CITY PLAN COMMISSION

FILE NUMBER: S234-101

REQUEST: An application to create one 1.83-acre lot from a tract of land in City Block 8806 on property located on Woody Road, southwest of C. F. Hawn Freeway/ U.S. Highway No. 175.

PRELIMINARY PLAT
HOLLOWAY @ WOODY ADDITION
 LOT 1, BLOCK A8806
 1.83 ACRE TRACT
 BEING ALL OF THAT CERTAIN
 TRACT CONVEYED TO
 14020 CF HAWN FWY LLC
 INSTRUMENT NO. 20240036408
 OFFICIAL PUBLIC RECORDS, DALLAS COUNTY, TEXAS
 SITUATED IN
 WASH DAVIDSON SURVEY, DISTRICT NO 394
 CITY OF DALLAS, DALLAS COUNTY, TEXAS
 CITY PLAN FILE NO. S234-101
 ENGINEER PLAN NO. 24040036408

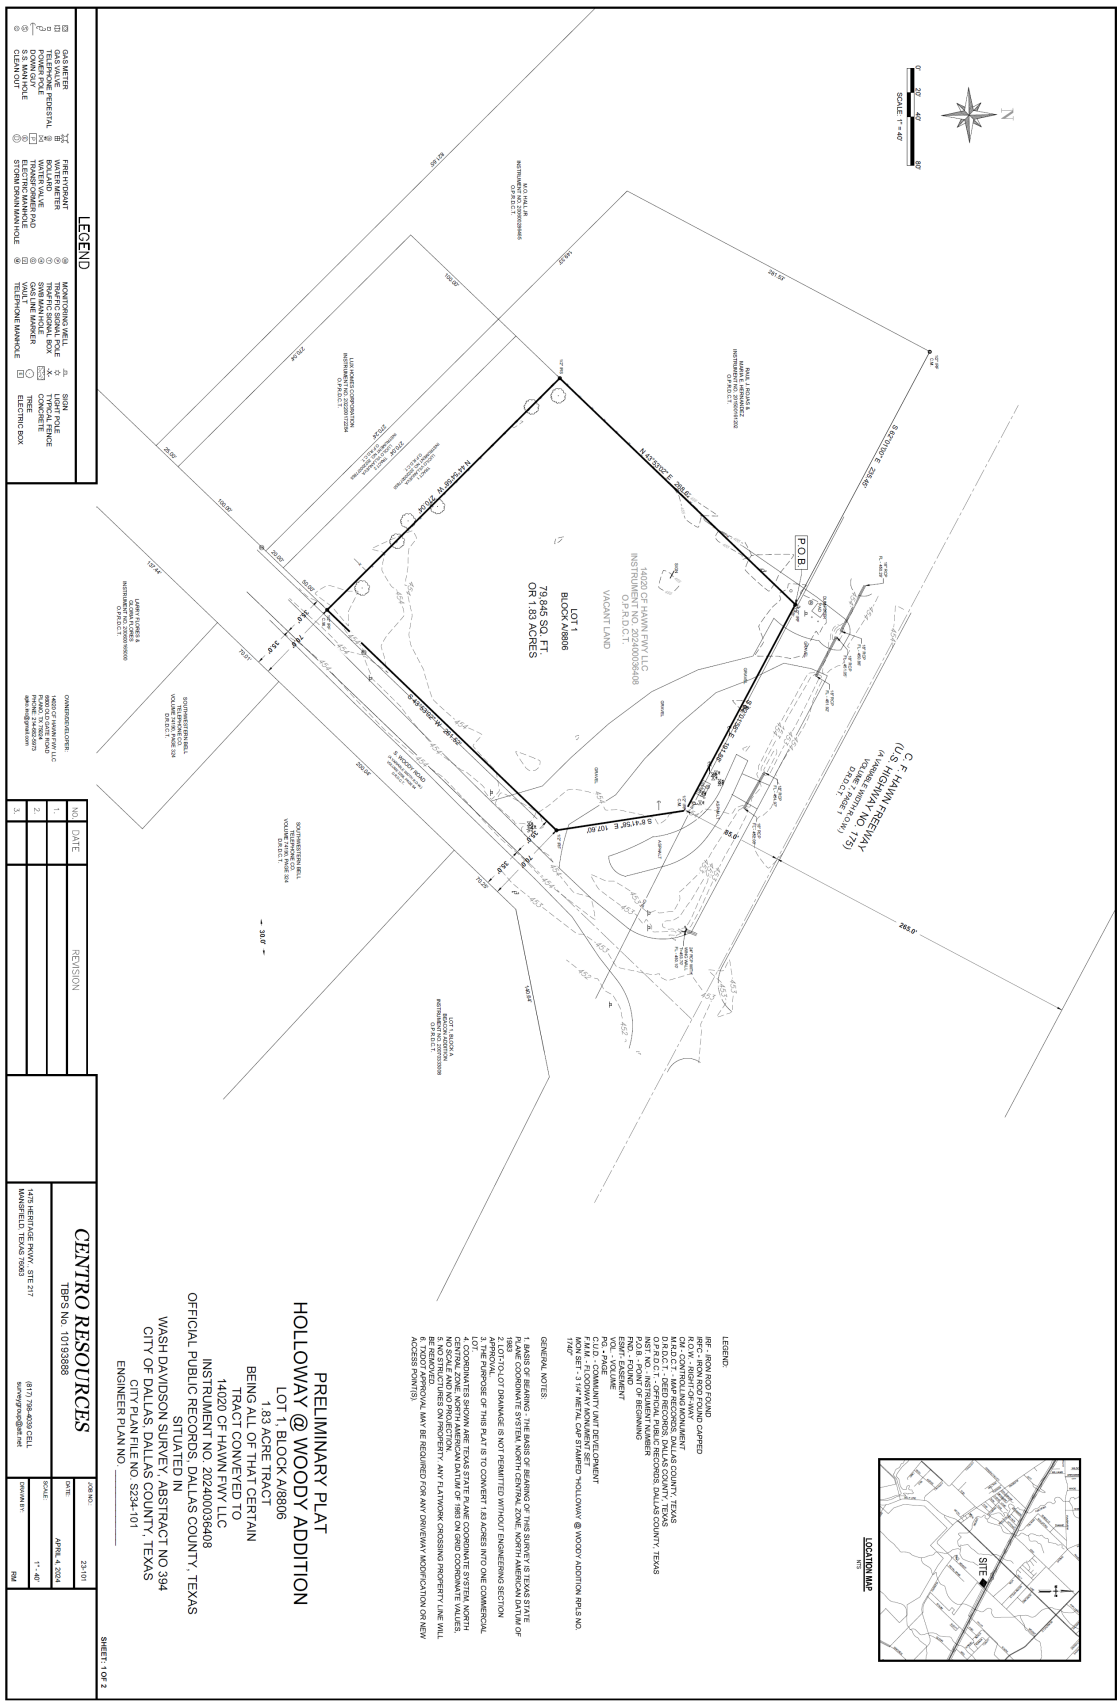
23. Prior to the final plat, any non-City related improvements located in right-of-way of C.F. Hawn Freeway will need to be relocated. Please provide documentation to Real Estate division to confirm.
24. On the final plat, change “S. Woody Road” to “Woody Road (AKA Woody Lane)”.
25. On the final plat, identify the property as Lot 1 in City Block N/8806.
